SUPPLEMENTARY REPORT:

598A & 598B Blaxland Road Eastwood. Lots A & B DP 396644. Local Development Application for construction of a part 3/part 4 storey residential apartment building containing 12 apartments with associated basement parking for 13 vehicles. LDA2018/90.

Item 4 was for LDA 2018/90 for the construction of a part 3/part 4 storey residential apartment building and at this meeting the Panel deferred the matter for electronic determination, pending a supplementary report addressing drainage solutions.

Figure 1: Proposed easement as required by deferred commencement condition 1, marked in red and the applicant's preferred easement shown in blue.

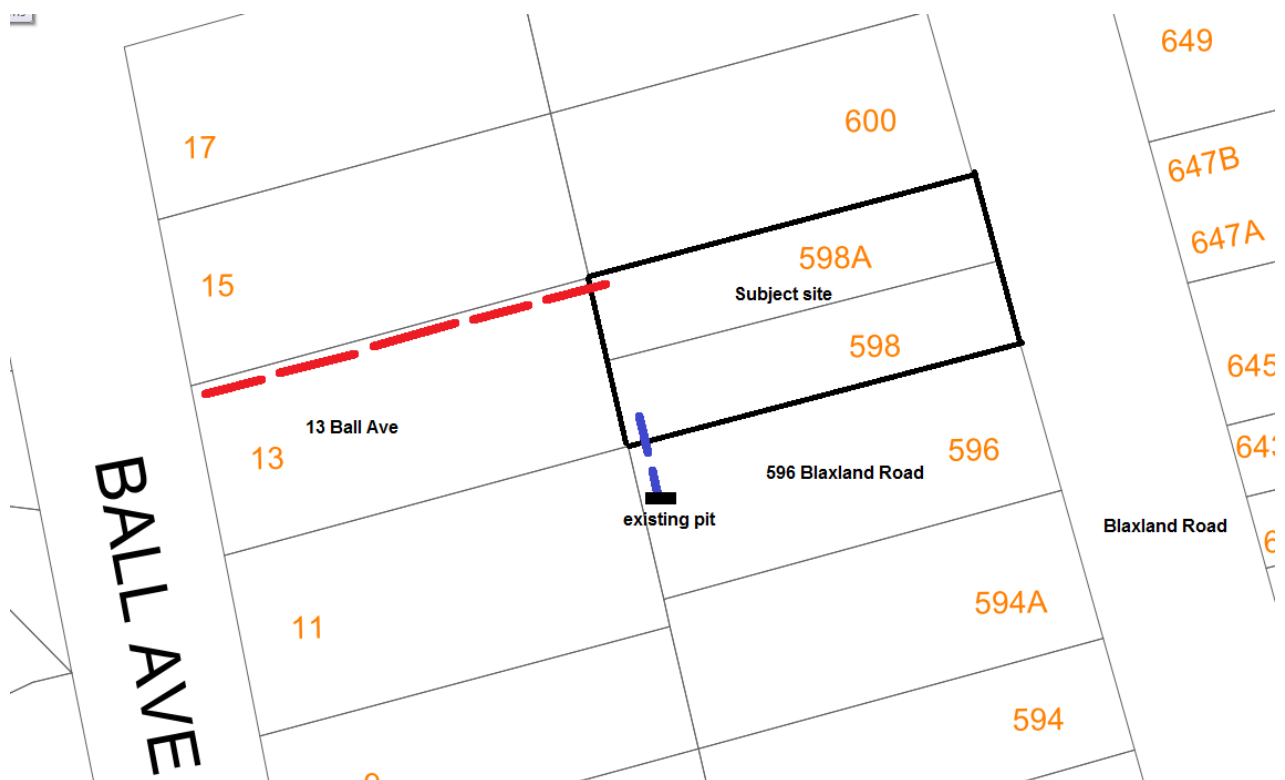
However at the meeting, the applicant advised that they have started preparation works to acquire an easement through 596 Blaxland Road, Eastwood (the adjoining southern property) rather than 13 Ball Avenue as stipulated in Deferred Commencement Condition 1. It was also noted that the stormwater plans referred in the Deferred Commencement Condition 2 above was not in accordance with revised plans and flood study sent to Council on 15 May which showed the easement through 596 Blaxland Road. The applicant advised that the easement through 596 Blaxland Road is the preferred option and proceedings had begun in the Land & Environment Court to obtain the easement via 596 Blaxland Road. Figure 1 below illustrates the proposed location of the easement at 13 Ball Ave, as required by the original deferred commencement condition, shown marked in red. The preferred easement through 596 Blaxland Road is shown marked in blue.

The revised stormwater management plans have diverted the alignment of the proposed easement route so as to now discharge to the public inground drainage infrastructure traversing the adjoining property at 596 Blaxland Road (just south of the subject lot). A review of the revised plans notes;

- The nominated angle of connection to the new junction pit is not hydraulically efficient with the angle of discharge against the dominant flow of the public drainage line. This could be redressed by having the realignment of the line undertaken at the point of discharge (within the confines of the easement) however will lead to significant hydraulic loss in the system. Considering the stormwater management system incorporates an onsite detention device which will restrict the rate of runoff to a degree which is well below the capacity of the discharge line the configuration does not warrant concern.*

- The design of the OSD system has not considered the potential for a submerged outlet anticipated to occur during extreme storm events. The invert of the OSD control point (orifice) is RL63.62m, the invert of the discharge point is RL63.51m and the anticipated 100yr ARI flood level at the point of discharge is anticipated to be RL64.19m. As such, the detention storage is unlikely to drain during extreme storm events, thereby making the OSD system ineffective. A review of the architectural plans notes that the area in which the tank is to be located (COMMUNAL OPEN SPACE) is to have a finished level of 64.90m. There is then provision to convert the area to an onsite detention basin by bunding the area (implementation of a small impermeable wall, similar to a garden bed around the perimeter of the area), effectively raising the discharge control such to be above the flood event. To prevent nuisance ponding occurring for smaller storm events, provision can be made for rainwater tank storage to be provided under the terrace to unit 1 and unit 2. The configuration presents an improved outcome in that there is a reduction in hardstand area (presented by the footprint of the below ground tank), it facilitates an increased level of landscaping and increases the degree of water permeation over the lot. This matter is addressed by condition of consent.*

1. **Drainage Easement.** *An easement to drain stormwater must be established over adjoining property(ies) in order for the development to legally drain via gravity to public drainage infrastructure. The easement is to be located generally as shown on the concept plan ACOR Consultants Pty Ltd. (Refer to Project No. SY170208 Dwgs C2.01 Rev J dated 7 August 2018), and is noted to discharge over No. 596 Blaxland Road (SP7549).*

- a. The proposed alteration to the public inground drainage infrastructure at the point of discharge will require the assessment and approval of Councils Stormwater Asset and Catchment Section. The proposed junction pit is to be cast in situ (not a proprietary product) and incorporate a sealed access lid. The civil construction plans are to clearly detail the works and are to depict, as a minimum, existing and proposed surface levels, invert levels of crucial sections of the infrastructure, a plan view of the connection and cross-section details. Full civil specifications relating to the works are to be incorporated on the plans. Any variation to the scope of works or modifications to this that may be required such as, arising due to site conditions, as identified in the detailed assessment or a requirement in Council's DCP, are to be undertaken at the direction or discretion of Council's Stormwater Asset and Catchment section.*
